East Venice Community Plan - Land Use Recommendations

August 2026

A Community Plan/Local Coastal Program Ad Hoc Committee Report Venice Neighborhood Council

Figure 2: Google Image of 2-Way Penmar Avenue at Victoria Avenue

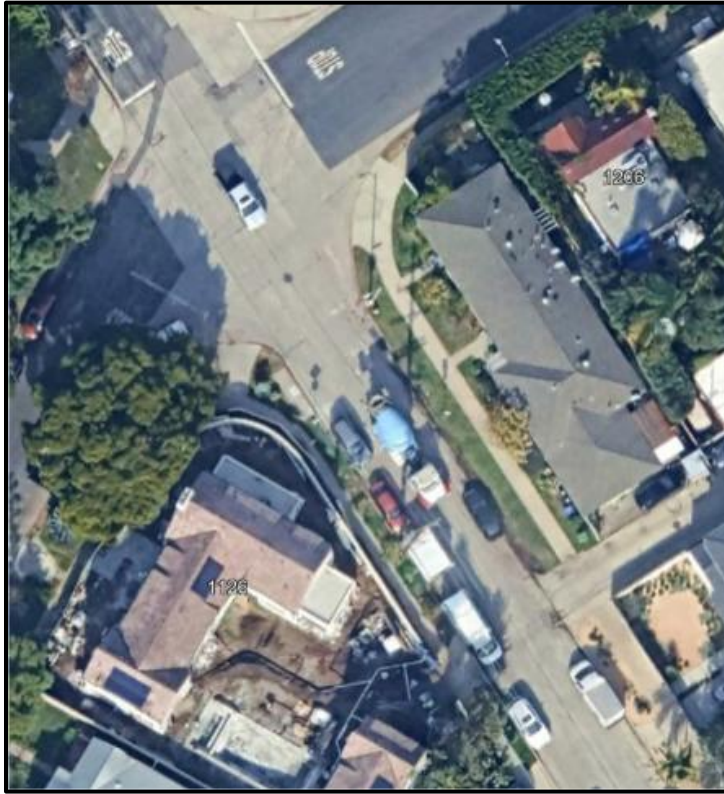
NavigateLA, the City's comprehensive mapping tool, indicates that the entire length of Penmar Avenue has a "(designated)" right-of-way width of 66 feet and a "(designated)" roadway width of 40 feet. The "(designated)" label means that, in the future, the City plans those dimensions for the presently narrow Penmar Avenue. However, the existing Penmar Avenue's actual roadway width south of Palms Avenue/Preston Way narrows from 40 feet to 26 feet, with only short intermediate blocks having widths of 36 feet or more. South of Amoroso Place/Carlton Way, Penmar Avenue is 26-feet wide all the way to Venice Boulevard. Two rows of parking (7' each) and two lanes of traffic (minimal 10' each next to parking lanes) should require 34 feet minimum width. Penmar Avenue would barely be wide enough if all parking is eliminated. Figure 2 is a Google Earth image of Penmar Avenue south of Amoroso/Carlton (at Victoria Avenue) that happens to capture just how narrow Penmar Avenue actually is.

Although this narrow condition exists only on the last one-third of Penmar Avenue, it makes driving anywhere on Penmar Avenue to Venice Boulevard difficult because opposing vehicles must slow down and in most cases one of them has to pull over to the side so that both can pass. Moreover, drivers can only turn west at Venice Boulevard. As more development occurs along Penmar Avenue before it is widened, likely decades in the future, driving south to Venice will become increasingly untenable. That will cause more driving through local streets to reach Venice Boulevard.

Figure 3: Penmar Avenue Between Amoroso Place and Venice Boulevard

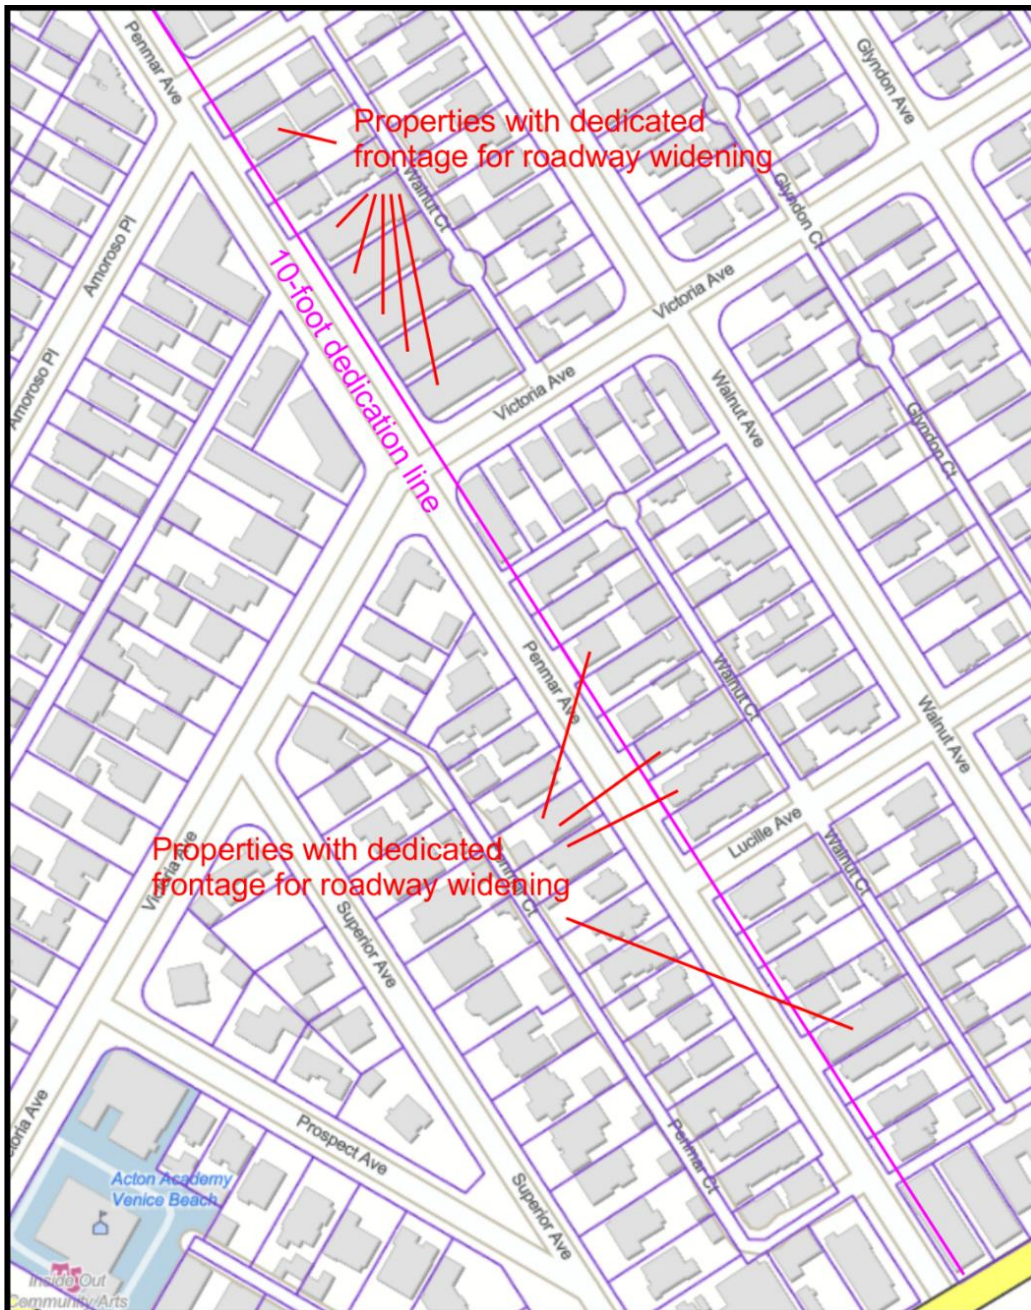
Since 1964, the City has required new developments along Penmar Avenue south of Amoroso Place to dedicate frontage so that the roadway can be widened at least 10 feet. However, after 62 years (the first development to set back its structures to allow a widened roadway was perhaps in 1964) only 10 of the 27 developments along this 0.3-mile section of Penmar Avenue have been built to allow for the future widening. Until all 27 properties are redeveloped, the road cannot be continuously widened. Figure 3 is a copy of L.A. County's Assessor's Map showing this section of Penmar Avenue and the present number of street dedications.

This section of Penmar Avenue should remain Low Medium Residential as City Planning proposed two years ago. City Planning has not provided any justification for the up-zoning. In 2024, City Planning proposed 3 stories (no bonuses) and a maximum FAR of 1.5.

Figure 4: East Venice Neighborhoods Between Venice Blvd and Washington Blvd

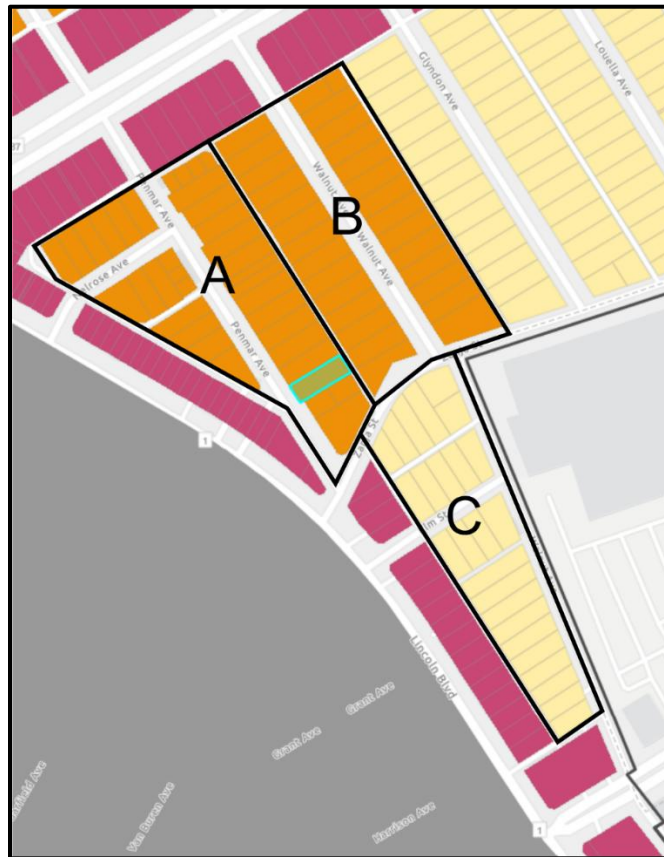
Although small, this area will be discussed in three parts: A. Penmar Avenue between Venice Boulevard and Zanja Street and Nelrose Avenue, B. Walnut Avenue between Venice Boulevard and Zanja Street, and C. Walnut Avenue south of Zanja Street including Elm Street. See Figure 4.

- A. **Penmar Avenue and Nelrose Avenue north of Zanja Street:** This area is presently classified as Low-Medium Residential and City Planning proposes now to up-zone it to Medium Residential. That would allow apartment/condos to be up to 8 stories (including bonuses).
- B. **Walnut Avenue north of Zanja Street:** This street is far less built up than Penmar Avenue. It is still characterized by 1- and 2-story homes.
- C. **Walnut Avenue and Elm Street south of Zanja Street:** This small single-family enclave will be bounded by very tall buildings proposed by City Planning along Lincoln Boulevard and by the high walls of Costco on its east side – hardly conducive to single-family living.

- Penmar Avenue and NelRose Avenue north of Zanja Street:** Penmar Avenue south of Venice Boulevard is about 28 feet wide, already too narrow for the many existing 3-4 story apartments along it (Nelrose Avenue is slightly wider). It is negligent to think that they will be able to handle the traffic of 7-8 story buildings. Thus, the Committee now recommends a density, height, and FAR only slightly higher than what it recommended in 2024, to reflect the reality of what exists there now.

- B. **Walnut Avenue north of Sanja Street:** The recommendation is to continue the existing Low Medium Residential classification that the VNC (and City Planning) recommended in 2024: a density of 2 DUs per lot, a maximum height of 3 stories $\leq 33'$ and a FAR of 0.75. This is what City Planning proposed in 2024.
- C. **Walnut Avenue and Elm Street south of Zanja Street:** The recommendation is that properties on Walnut Avenue and Elm Street south of Zanja Street be up-zoned from Low Residential to Medium Residential.
